From: Scala, Mary Joy
Sent: Friday, August 22, 2014 2:06 PM
To: William H. Atwood (atwood@scscharlottesville.com); Hadley Rodland (hadley@scscharlottesville.com)
Cc: 'btreakle@jetreakle.com'; 'reachme33@gmail.com'; 'Mark Kestner'
Subject: BAR Actions - August 19, 2014 - 501 W Main Street

Certificate of Appropriateness Application

BAR 14-07-03

The Sutton Group, LLC, and Andrew Levine, Owners/ Southern Cities Studio, Agent, Applicant
New mixed-use complex

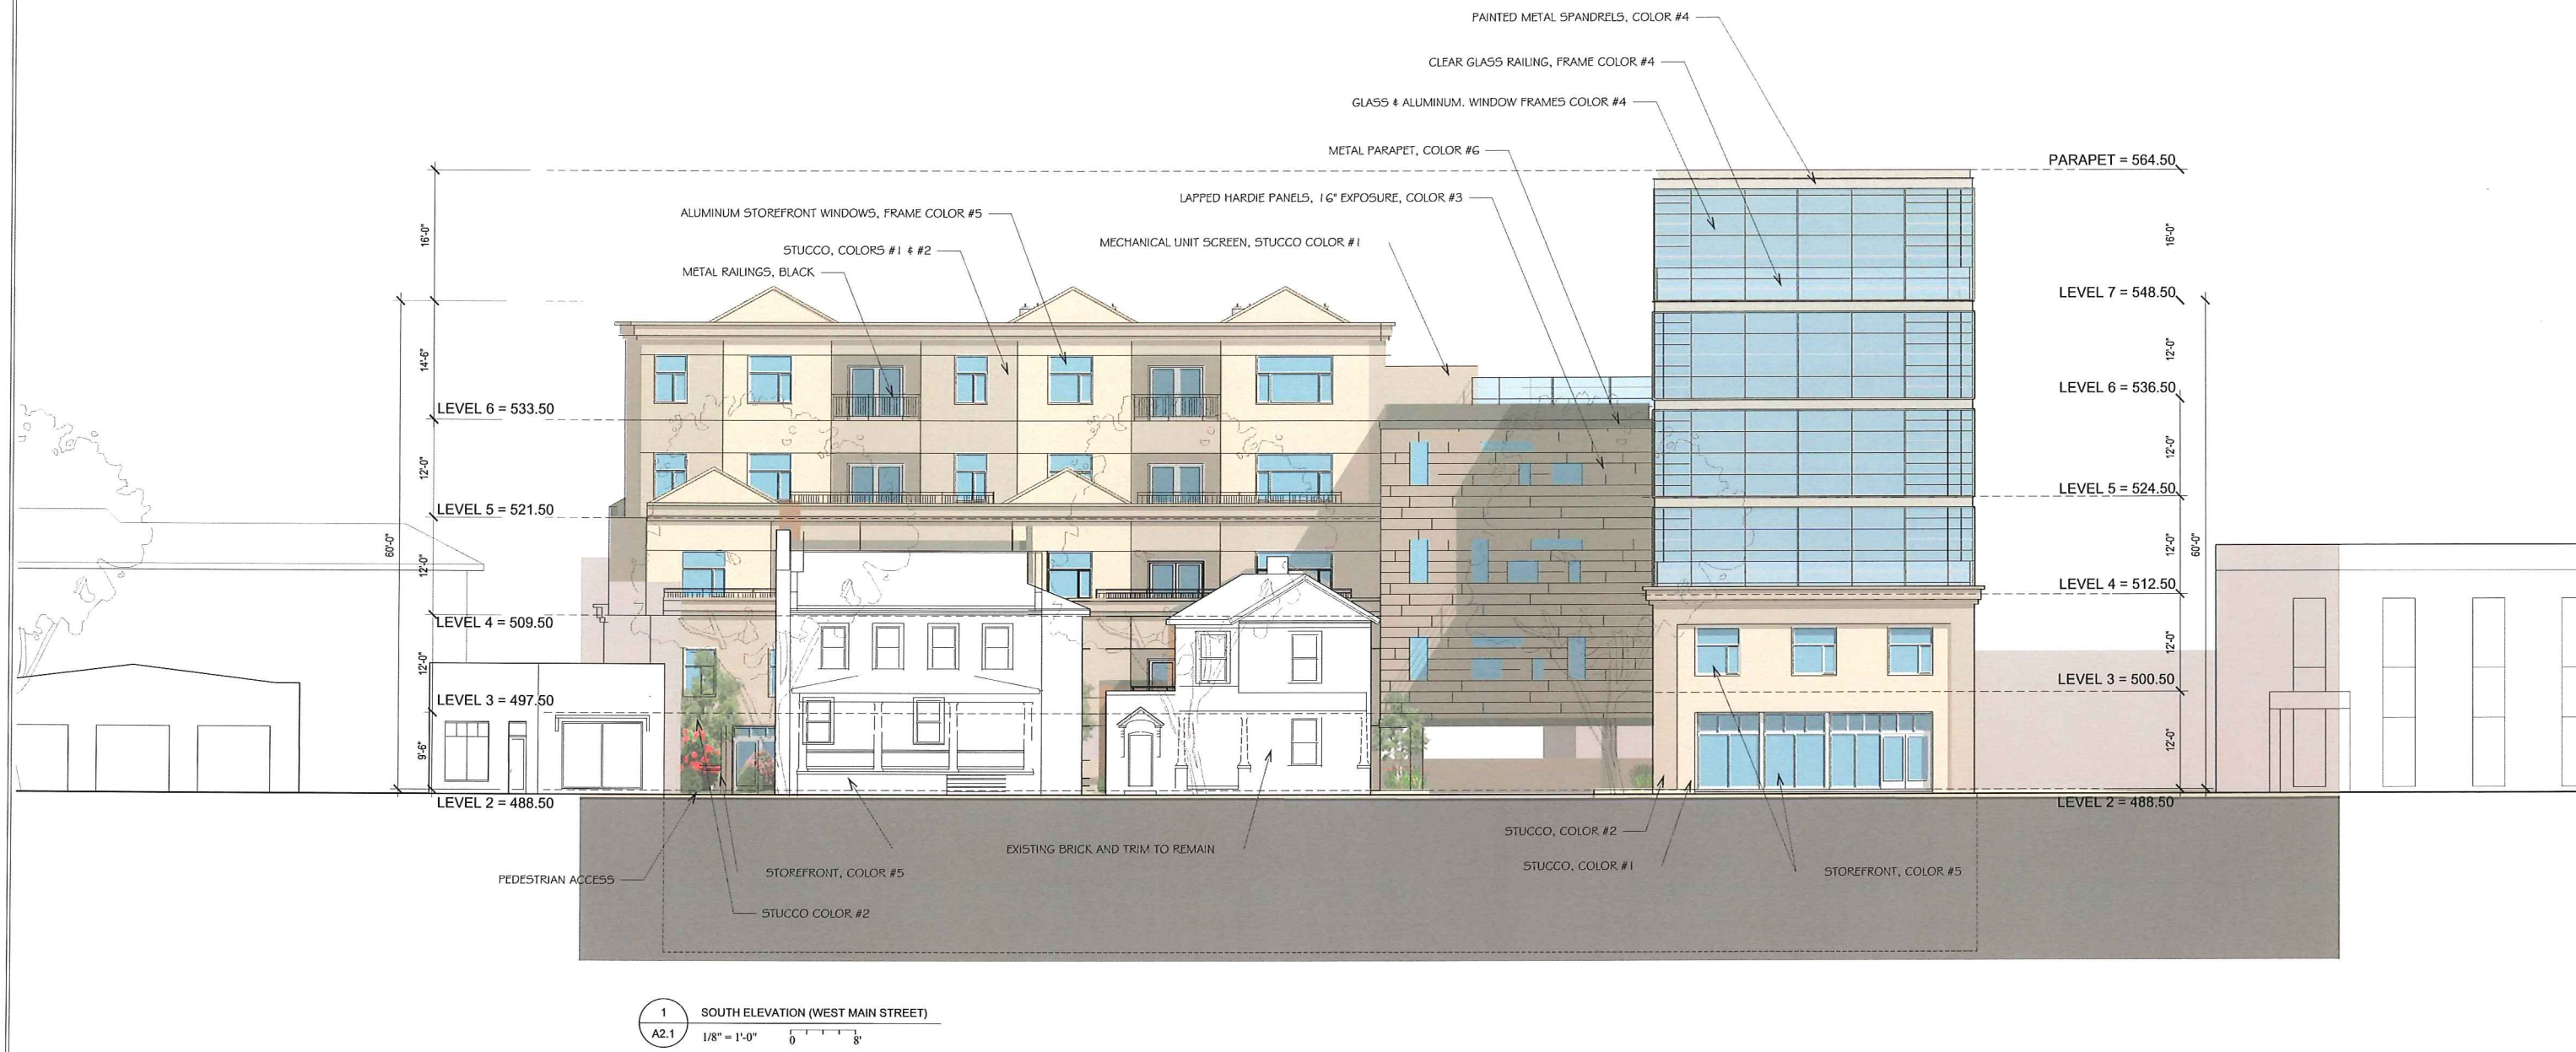
Are appurtenances calculated correctly?

I have asked the Zoning Administrator for an interpretation on the appurtenance calculation. The audio recording of the meeting is not working online, but I can email you an audio tape if you want to listen to the meeting. If you have any questions, please contact me at 434-970-3130 or scala@charlottesville.org.

1
A2.2
NORTH ELEVATION (COMMERCE STREET)
1/8" = 1'-0"
0 8'

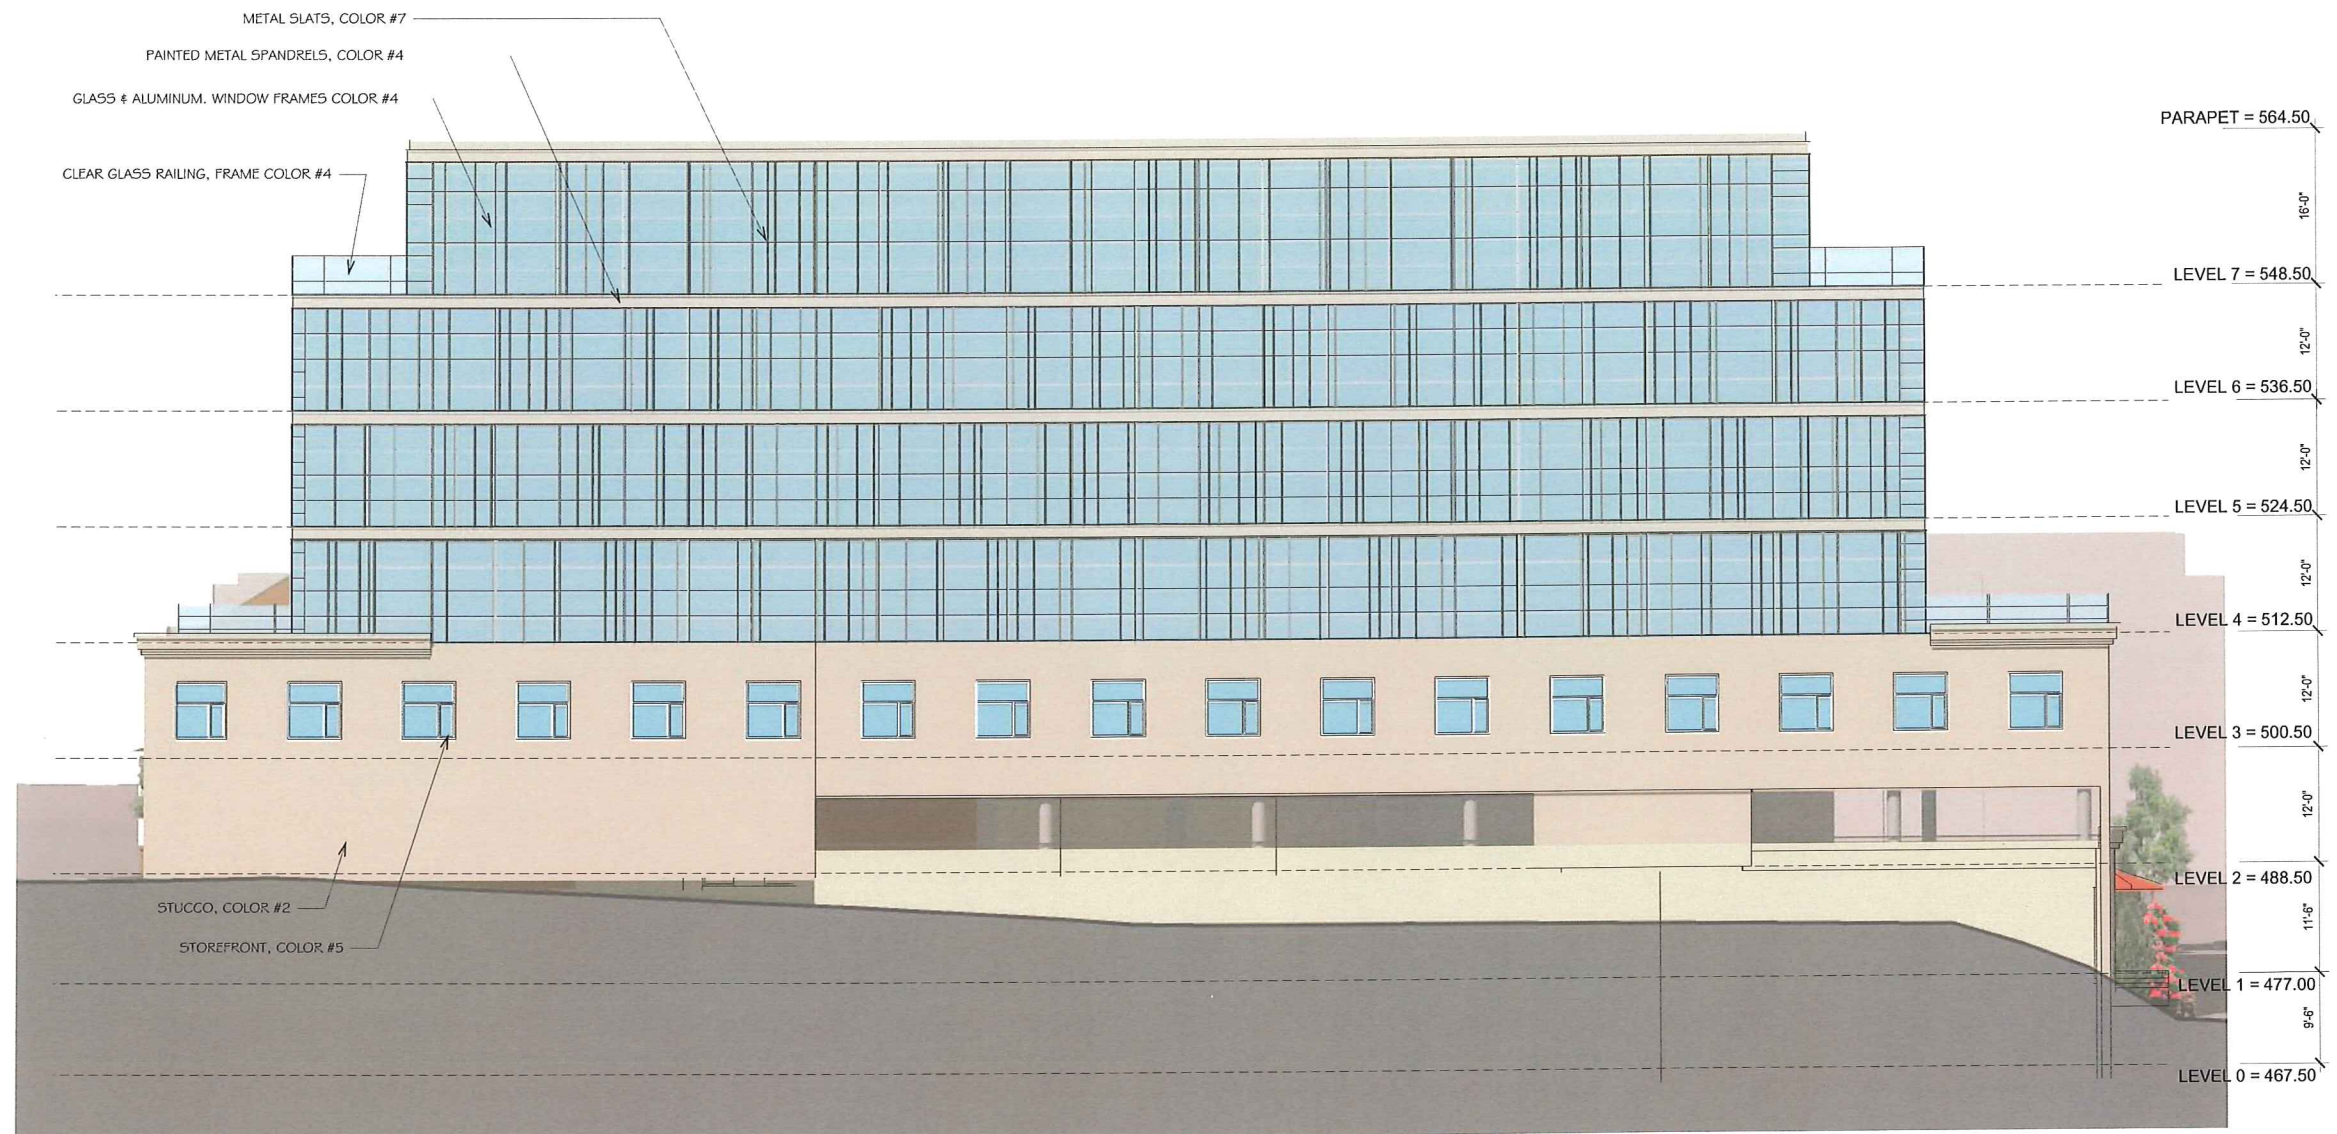
Commerce Street building should not be horizontal; should be broken up into narrow widths (storefront module) with more verticality.

Elevation drawings are needed for all four sides of the project, with the Commerce Street frontage deserving as much attention as West Main Street. Although a structured garage is permitted to front on Commerce Street, considered a linking not a primary street, the garage should respect, and be compatible with, the historic buildings that surround it.
